**City of Ketchum** Planning & Building

### STAFF REPORT KETCHUM PLANNING AND ZONING COMMISSION REGULAR MEETING OF JANUARY 24, 2023

- **PROJECT:** Appellation Hotel (formerly Harriman Hotel)
- FILE NUMBER: P22-059 and P22-059A
- APPLICATION TYPE: Design Review (P22-059A) Development Agreement Amendment (P22-059)

TO:	Morgan Landers / City of Ketchum Jack Bariteau/ HH LLC
FROM:	John C. Davis
DATE:	January 11, 2023/Updated January 18, 2023
SUBJECT:	Design Review Comments Response Appellation/Sun Valley Hotel Ketchum, Idaho

Figure 3: Hwy 75 Elevation

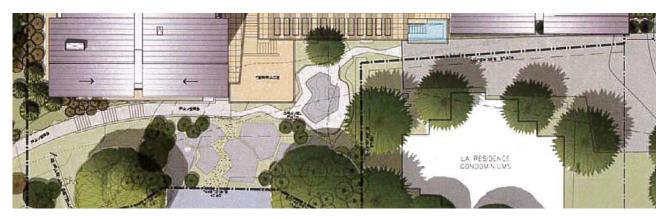
Staff's concerns regarding the height of the wall remain. The applicant expressed desire to provide a comfortable space for the patrons of the restaurant that will sit outside and proposed the concrete wall as it holds some sound dampening qualities and a feeling of protection/buffer from Hwy 75. Staff acknowledges this desire and believes that alternative materials/treatments can be used for a similar effect. Staff recommends the applicant utilize a transparent railing from the finished floor upward or implement a combination of wall and transparent railing to break up the upper portion of the wall.

Figure 6: January 2023 Proposal

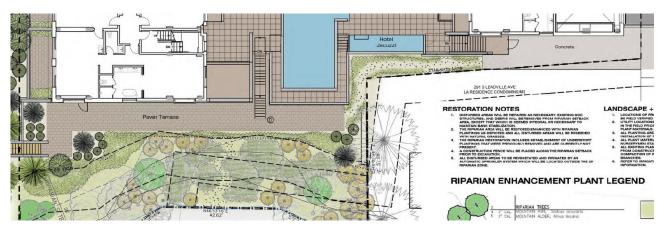
In December, staff raised concerns related to:

- Buffer between the jacuzzi/pool deck and the adjacent property
- Landscape buffer between the paver terrace and riparian area
- Location of the pedestrian entrance to the building

The applicant has not made changes to the paver terrace along the riparian area but has moved the stair location further to the west than proposed in December, which was a staff concern expressed. Staff's primary concern related to the paver terrace is the type of landscaping proposed along the end of the terrace as it transitions to the riparian area. The riparian area should be buffered in a way to protect against trash and debris and additional social trail development. Trash receptacles and a landscaped hedge which focused foot traffic onto the designated path could serve to address these concerns.

As shown on Sheet L3.0 of Attachment B, the current proposal has reworked the pool deck including a rotation of the pool 90 degrees and relocated the jacuzzi. The size of the jacuzzi has reduced and is in a similar area of the pool deck as the original approval. A landscape buffer has been reintroduced between the pool deck and the adjacent property to the east, although the buffer is much smaller than originally approved in 2008 as shown in Figure 4 above. As dimensioned on Sheet L1.1 of Attachment B, the current proposal sets the pool deck 6.5 feet from the property line to the

east allowing for some low-lying landscaping and a gravel walking path which provides egress to Leadville Ave. Staff believes this configuration is an improvement from the initial proposal in December and is supportive of the change. Staff does recommend consideration of creeping vines or other wall vegetation along the walls facing the adjacent residential property to provide relief and screening of the hard surface. Design Review Criteria #26 states *"Substantial landscaping is to be provided, which is in scale with the development and which provides relief from and screening of hard surfaces. Total building surface area and street frontage will be considered when determining whether substantial landscape is being provided. (Landscape shall be defined as trees, shrubs, planters, hanging plants, ground cover, and other living vegetation)".*

Figure 7: Design Principles, Gateway Area Mass and Scale Study

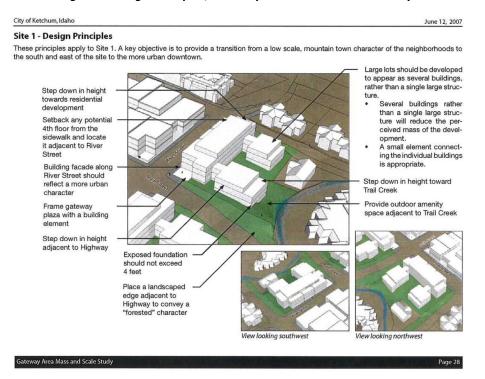
The Gateway Area Mass and Scale Study contemplated a four-story building with a step back of the fourth floor towards Trail Creek as shown in Figure 7 below.

# Roof Plan/Site Plan

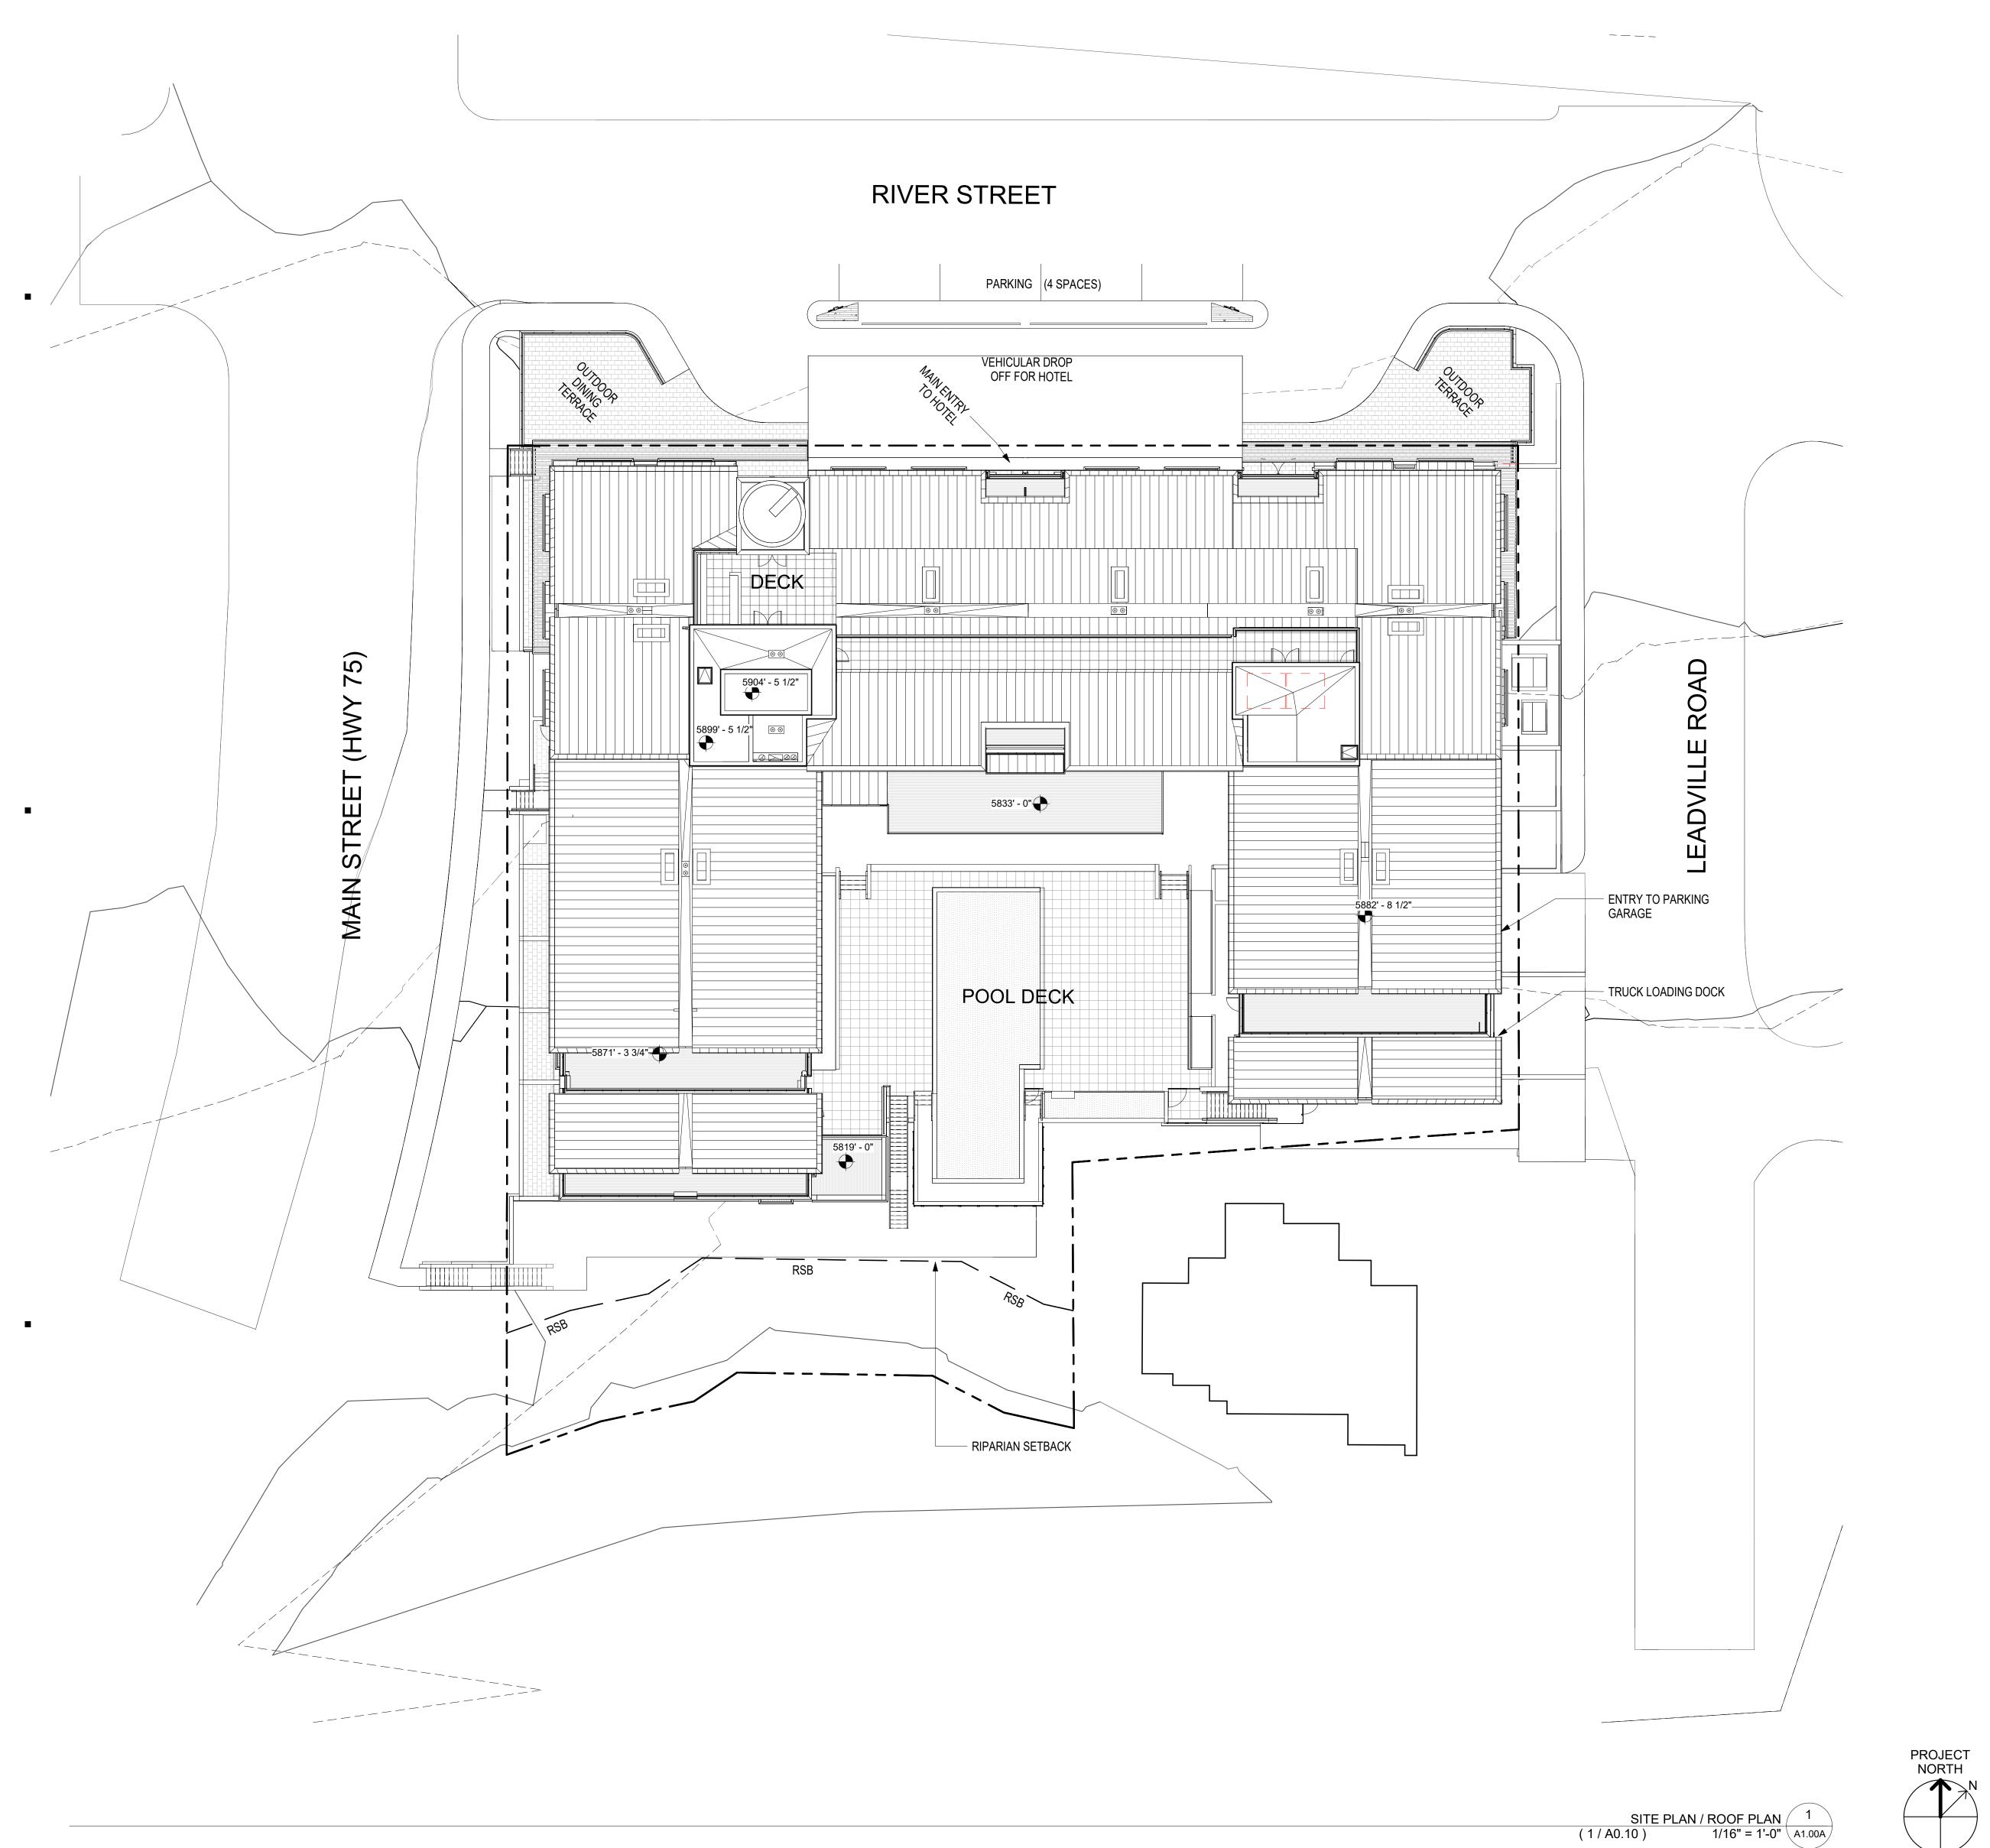
- 2.1 Building Plans:
  - At City request, the Building Floor Plans have been reissued showing the property lines and north arrow designation (no other plan changes have been made).
  - At City request, a Roof Plan has been added and included superimposed on the Site Plan, also indicating properly lines.
- 2.2 Overall Exterior Materials:
  - Palette has been changed to a warmer ensemble of materials; refer Materials to revised materials palette boards and as reflected on colored Boards elevations and renderings.
